Access Compliance Report

Public Rights-of-Way

Intersection ID: 50604	Main Street: RHODORA_RD	Cross Street: LAMINA_CT	Location: SE
ADA ID: E7667E98C235	Ramp Type: Perp	Initial Pass/Fail: Fail	Overall Compliance: No
Severity Score: 21.25			
Codes/Mitigation Info/Possible Solution		Field Measurements/Component Compliance

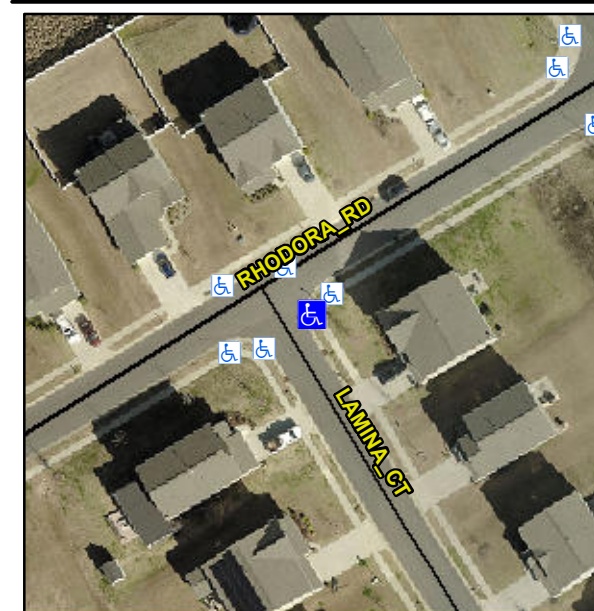
Not Found, R304.5.1, R304.2.2

Compliance	Description	Data	Compliance	Description	Data
N/A	Ramp Length (in)	48.5	No	Ramp Slope (%)	9.3
No	Ramp Width (in)	47.0	Yes	Ramp XSlope (%)	1.6
N/A	Flare Type LT	N/A	N/A	Flare Type RT	N/A
N/A	Flare Slope LT (%)	N/A	N/A	Flare Slope RT (%)	N/A
N/A	Flare Traversable LT?	N/A	N/A	Flare Traversable RT?	N/A
N/A	Landing Length (in)	N/A	N/A	DWS Provided?	N/A
N/A	Landing Width (in)	N/A	N/A	DWS Contrast?	N/A
N/A	Landing Slope (%)	N/A	N/A	DWS Length (in)	N/A
N/A	Landing X Slope (%)	N/A	N/A	DWS Full Width?	N/A
N/A	Landing Curb? (Y/N)	N/A	N/A	DWS Offset (in)	N/A
N/A	Shared Landing?	N/A			
N/A	Gutter Ponding?	N/A	N/A	Gutter Slope (%)	N/A
N/A	Gutter Lip Ht (in)	N/A	N/A	Gutter X Slope (%)	N/A
N/A	Painted X Walk1?	No	N/A	Painted X Walk2?	N/A
	X Walk 1 Direction	To W		X Walk 2 Direction	N/A
N/A	X Walk 1 Width (in)	N/A	N/A	X Walk 2 Width (in)	N/A
	X Walk 1 Slope (%)	0.6		X Walk 2 Slope (%)	N/A
	X Walk 1 X Slope (%)	1.1		X Walk 2 X Slope (%)	N/A

Remove & Replace Entire Ramp.
